AMENDMENTS

In The Drawings

FIG. 1

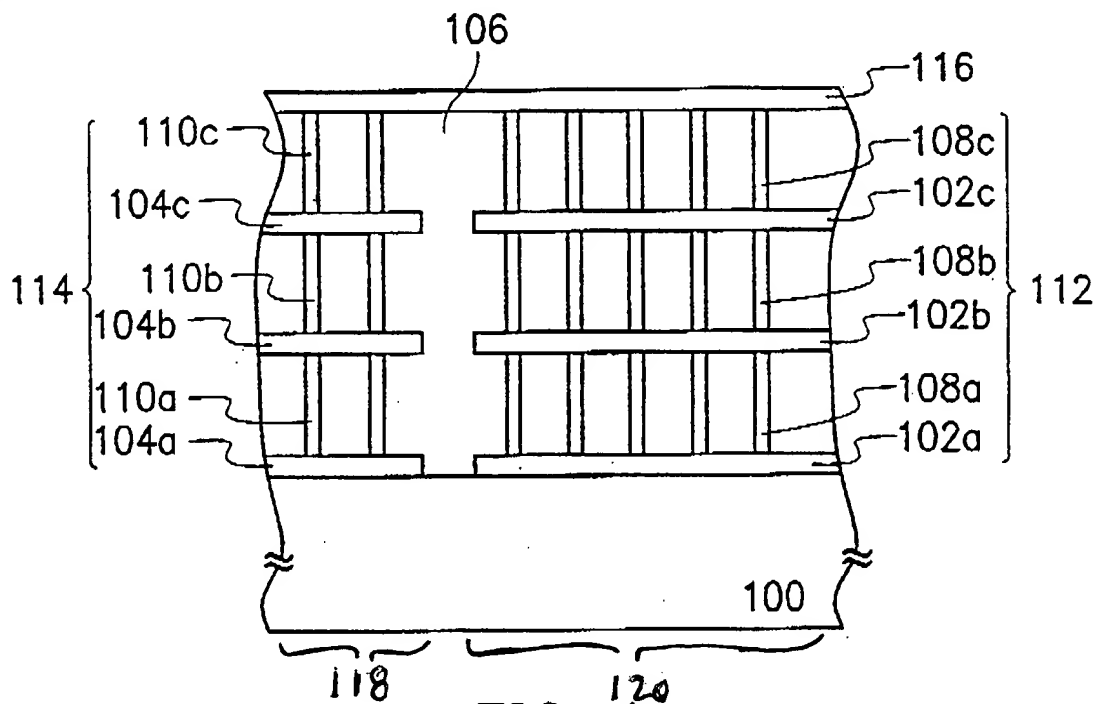
Please replace the original FIG. 1 with the amended one that is marked with red ink.
